PROPOSED IGA SUPERMARKET

### **SECTION 4.55 (1A) MODIFICATION of**

Development Consent No. 2018/LD-013 Rev 01
Demolition of the existing structures and construction of a supermarket

#### **MODIFICATION STATEMENT**

FIRST FLOOR PLAN

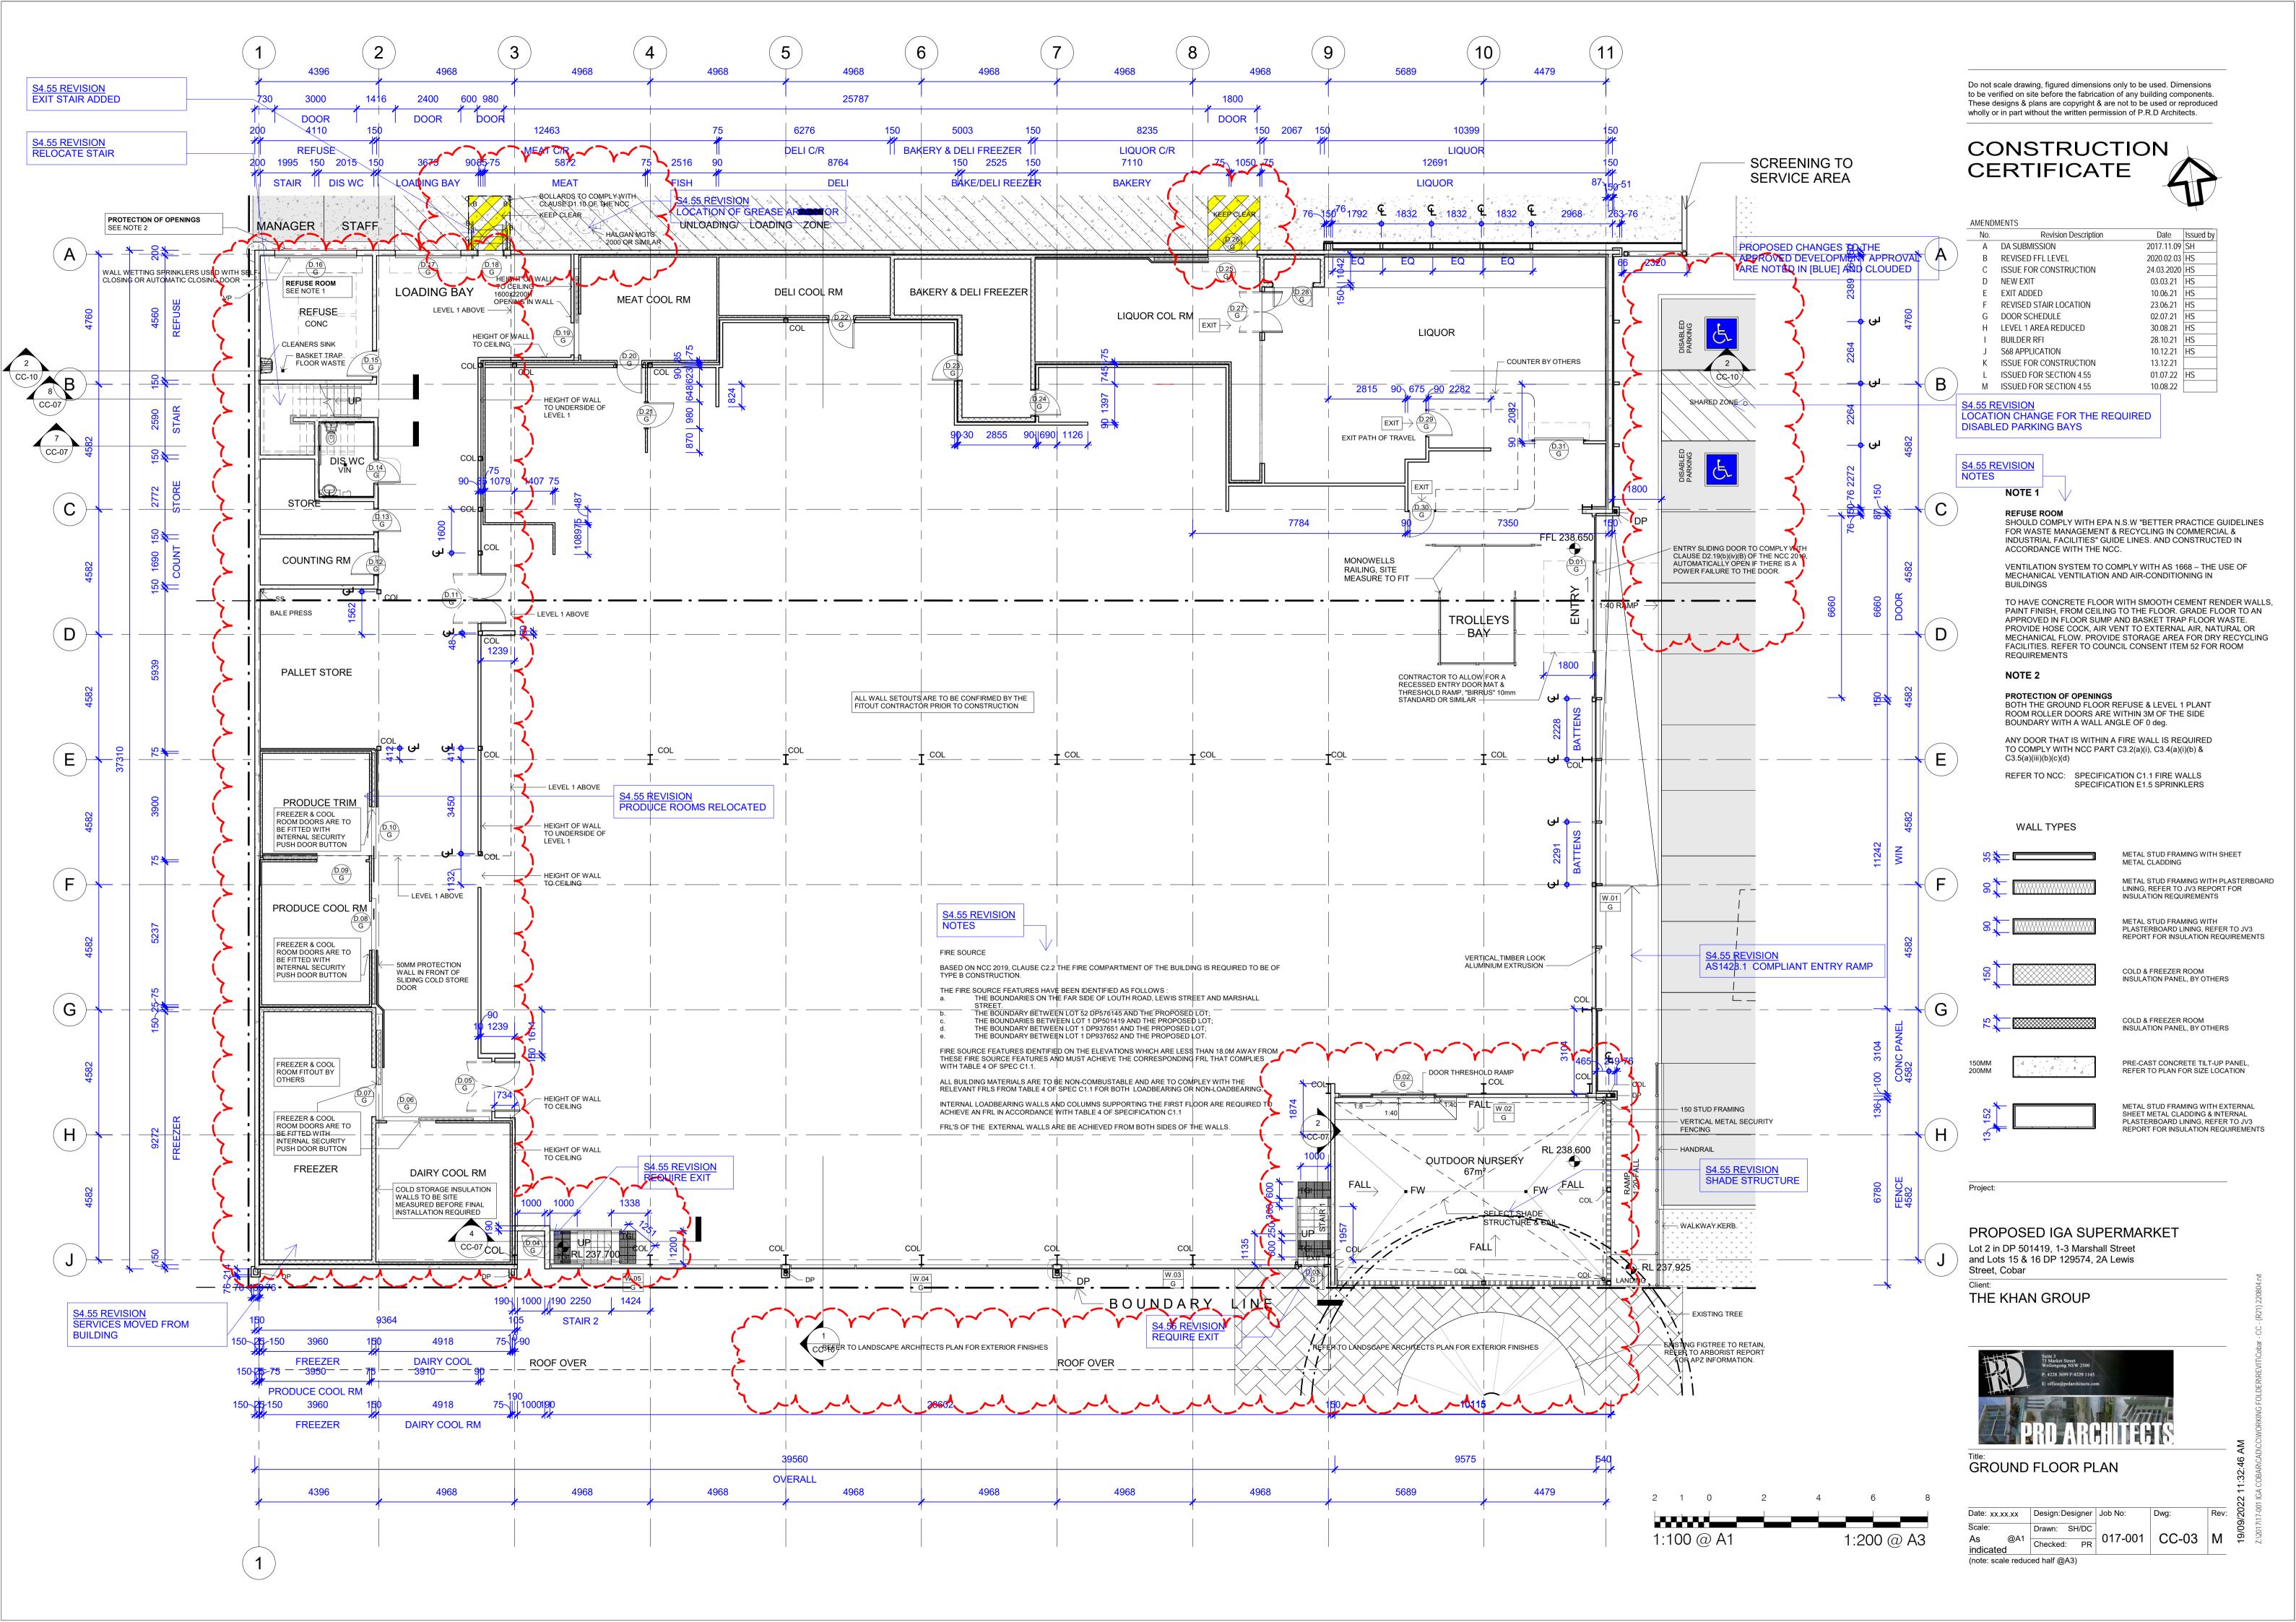
- Addition of exit stairs adjacent to loading bay
- Addition of required exit doors to southwest and southeast of the main supermarket floor
- Relocate internal stair from grid F to grid B to comply with the Fire exit path of travel distance of the first floor
- Addition of shade structure over outdoor nursery
- Reduction in floor area to the first floor office and plant rooms to 200m2 to comply with NCC part D1.4 and NCC D3.3 to be exempted from the use of a passenger lift or ramp to service the first floor, also resulting in minor planning changes.
- Reorient the plant room stair ladder for better plant layout and access to roof top plant condenser platform

## ELEVATIONS

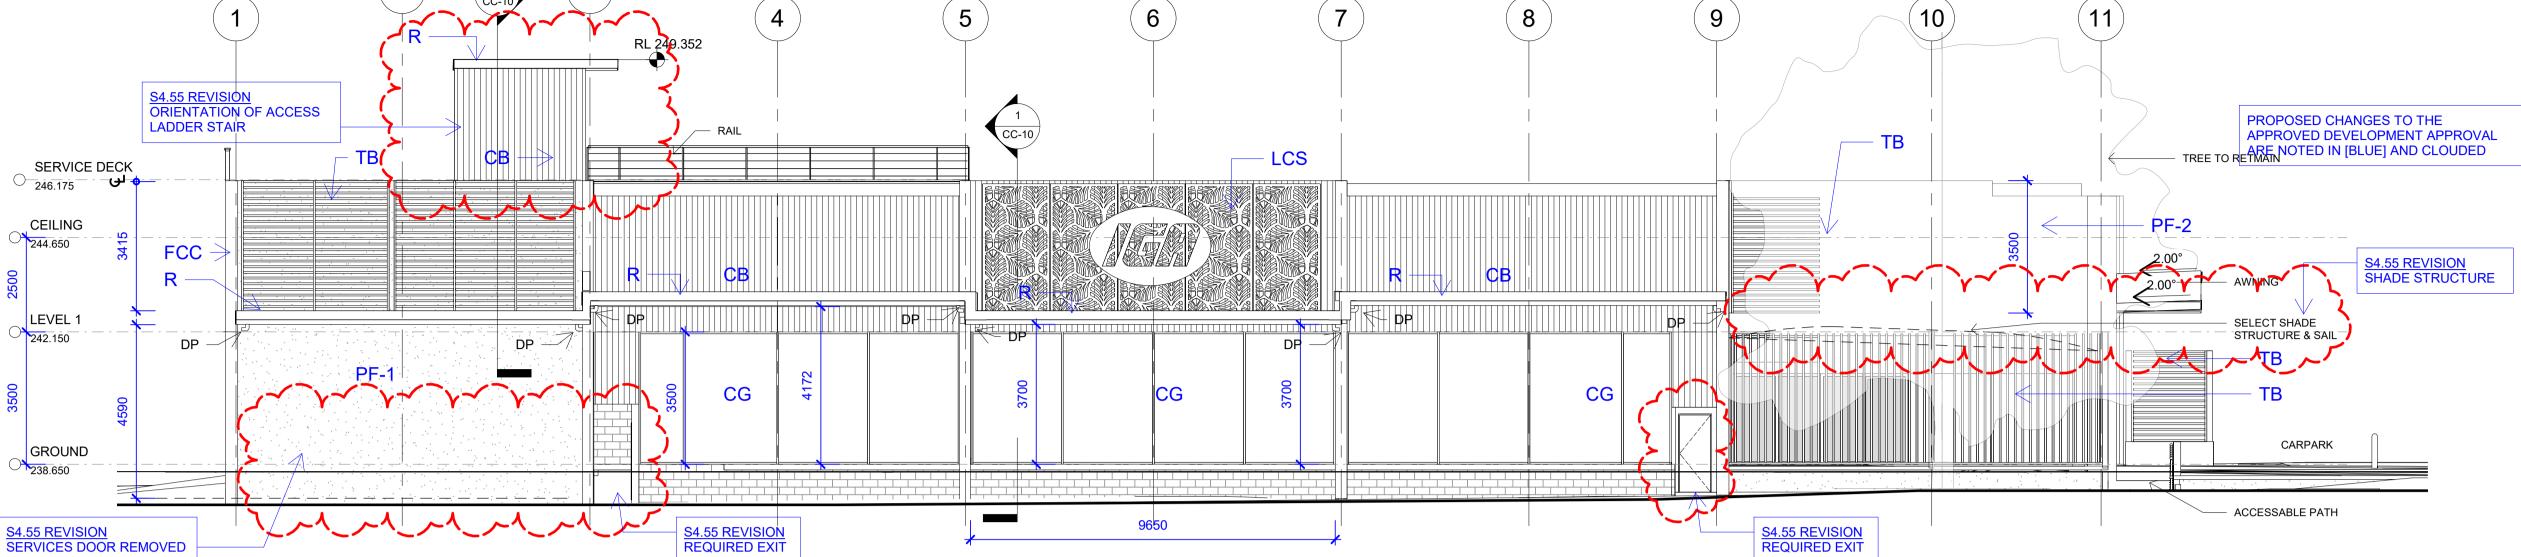
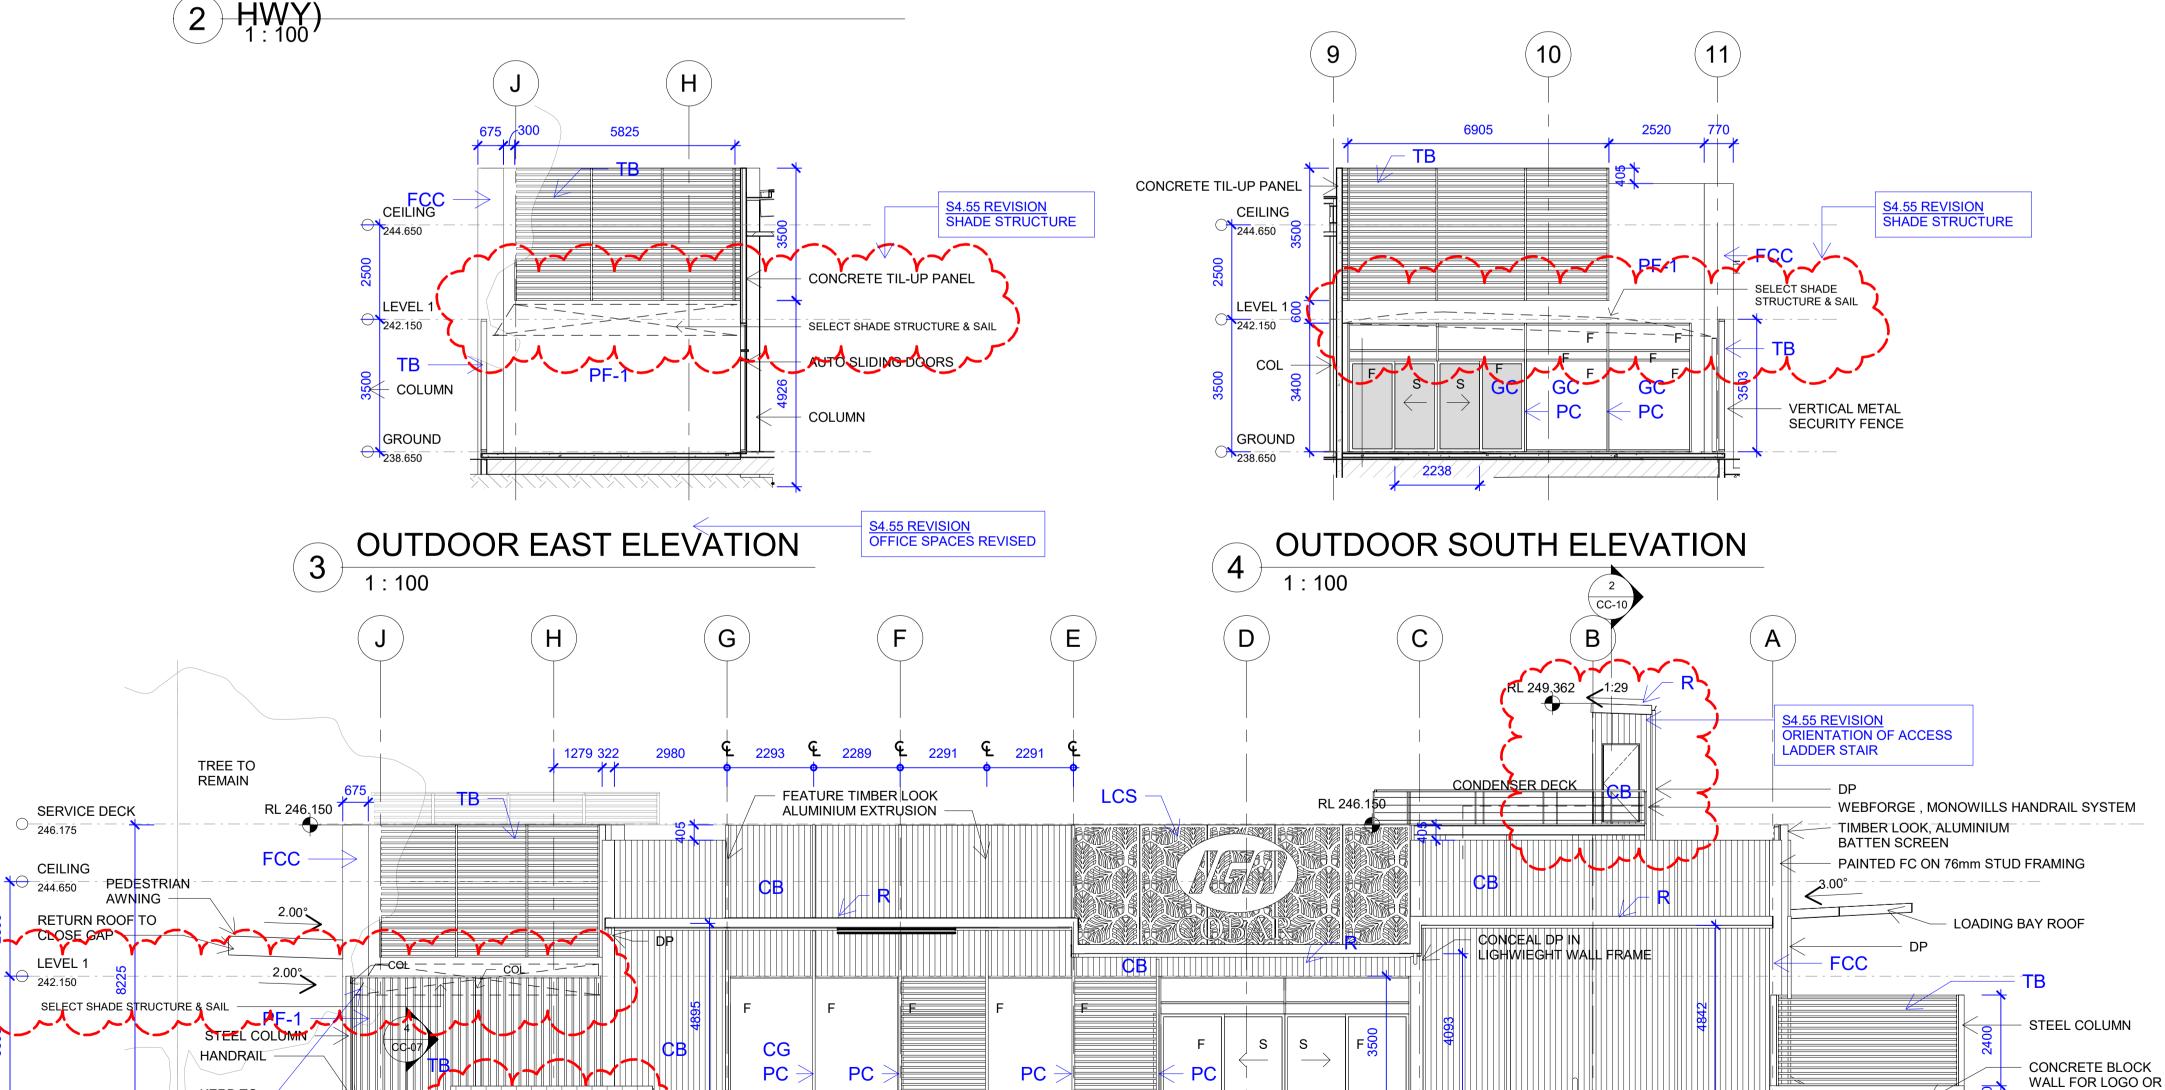
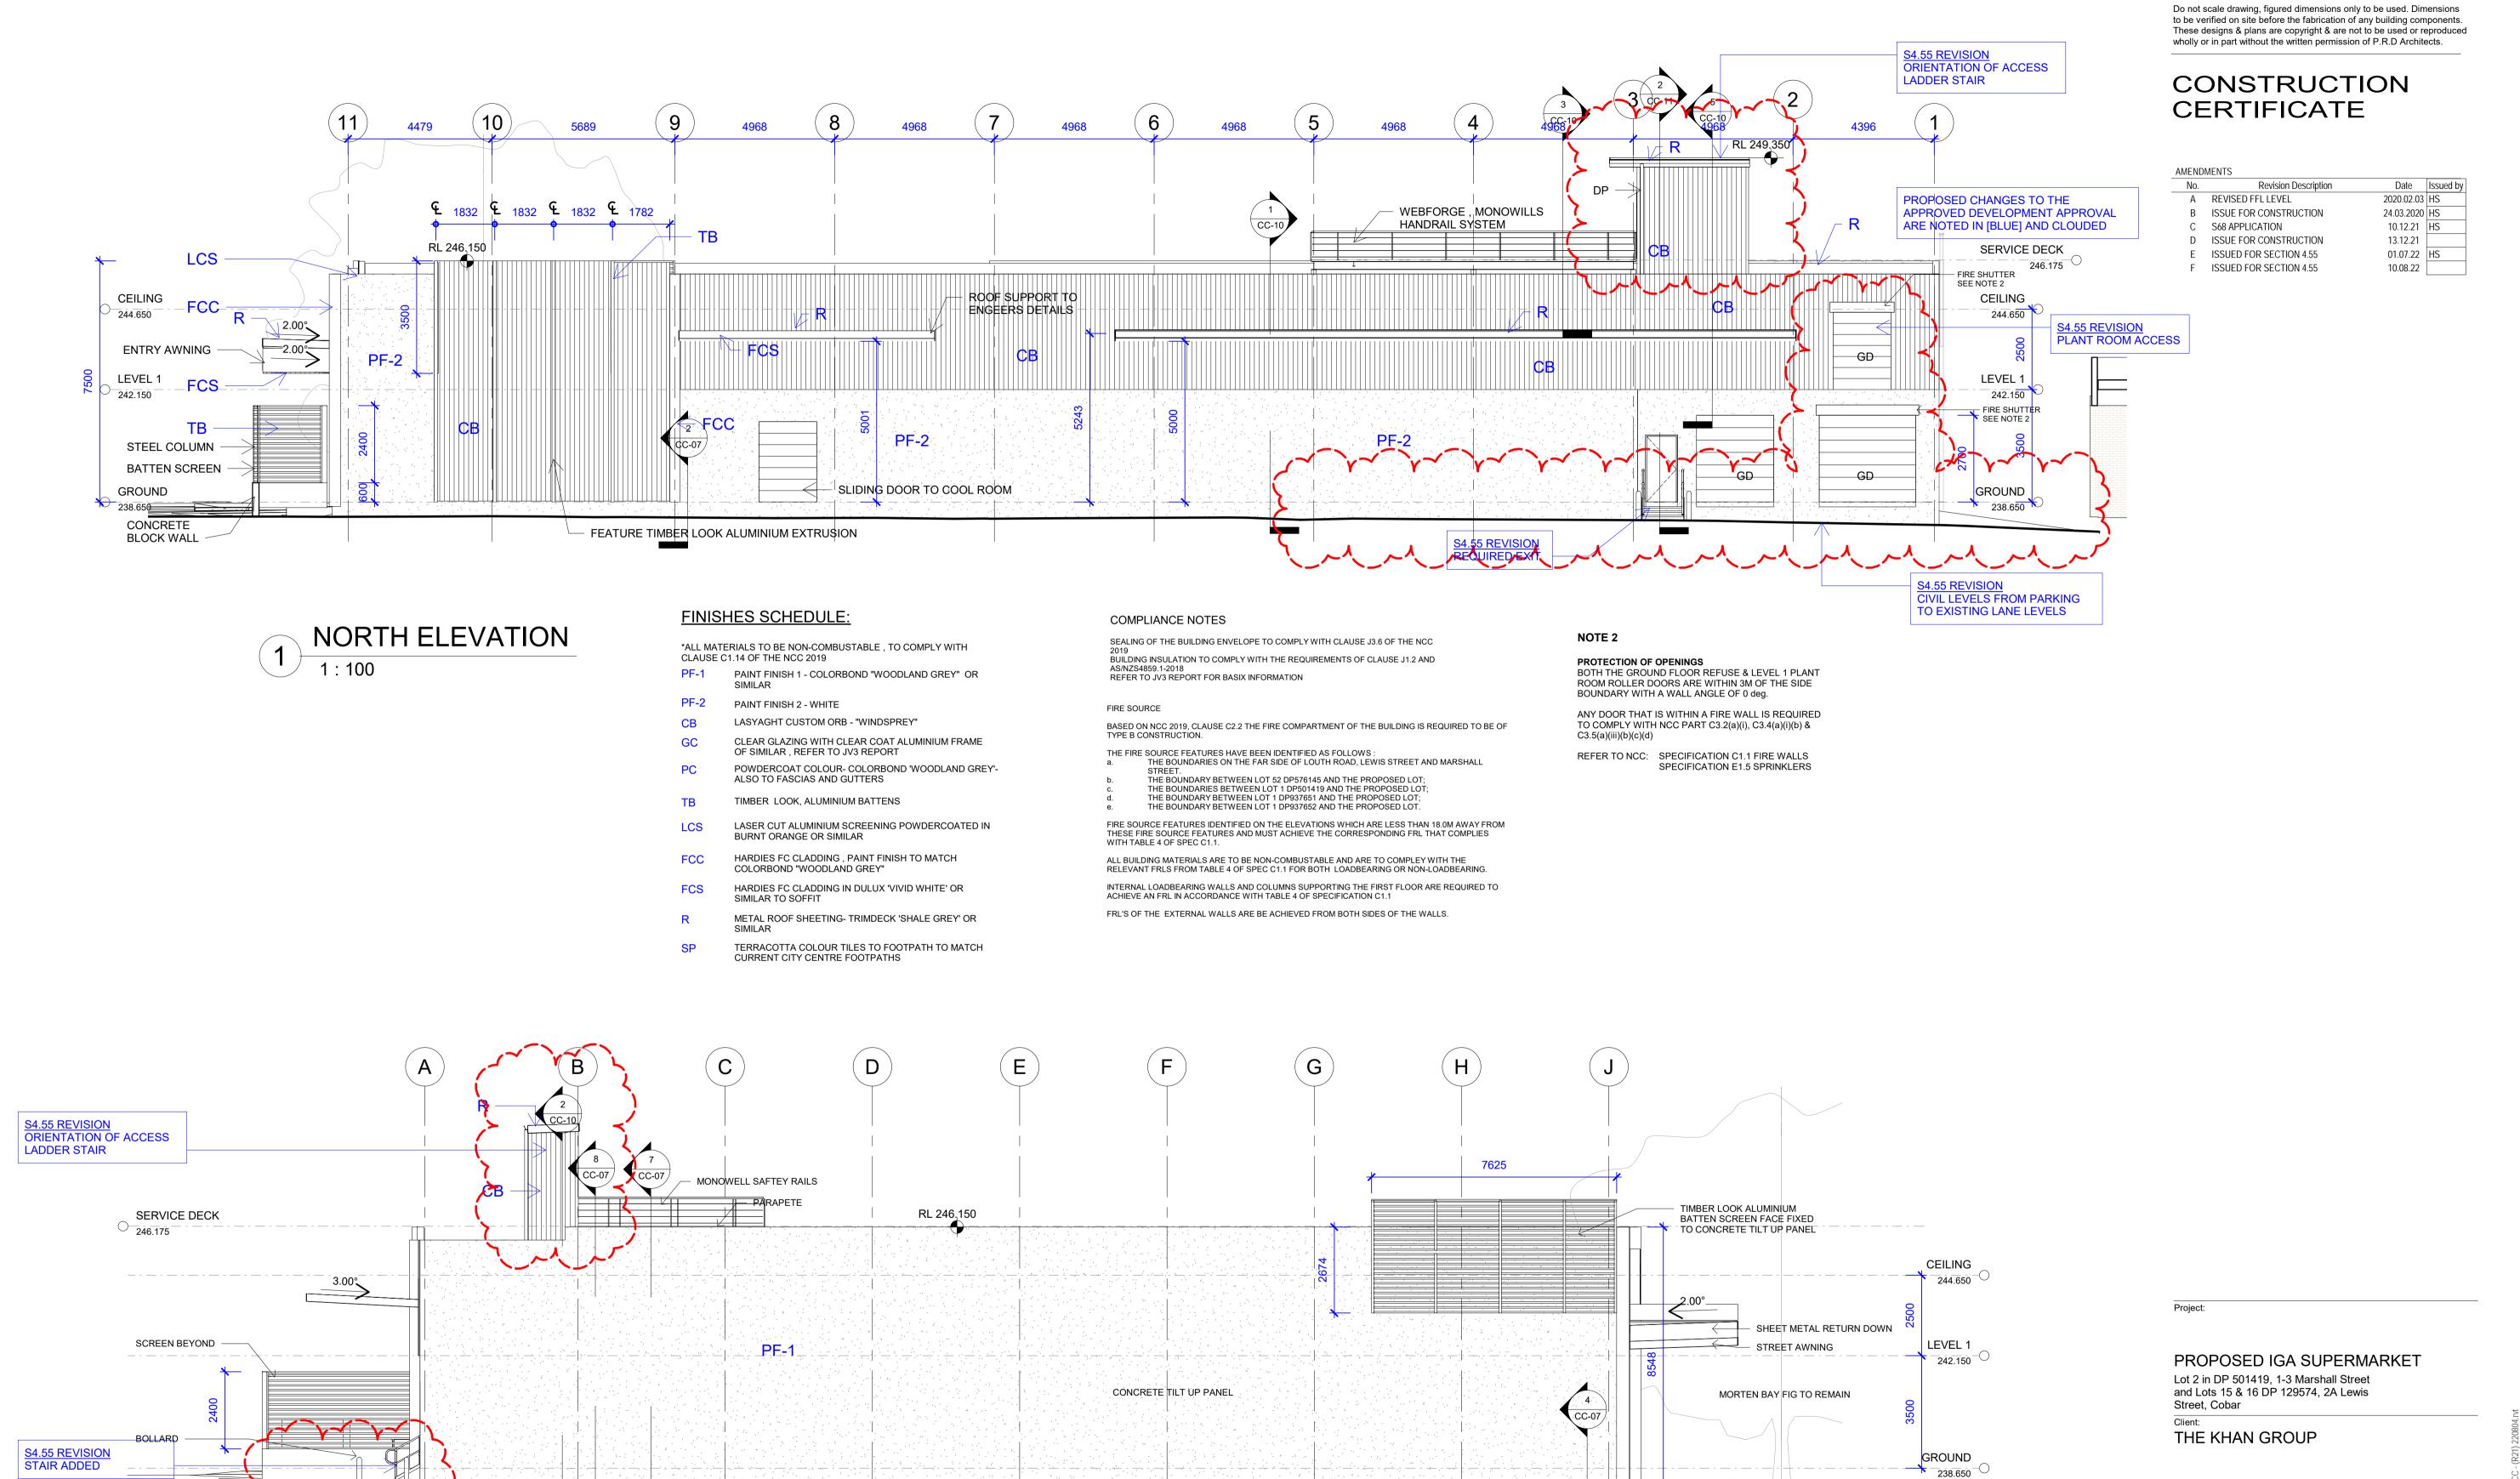
S4.55 REVISION SHADE STRUCTURE

- Reorient the plant room stair ladder for better plant layout and access to roof top plant condenser platform
- External parking levels to match existing lane level, north elevation

- Addition of shade structure over outdoor nursery
- Addition of required exit doors to south elevations
- Plant room access door, north elevation
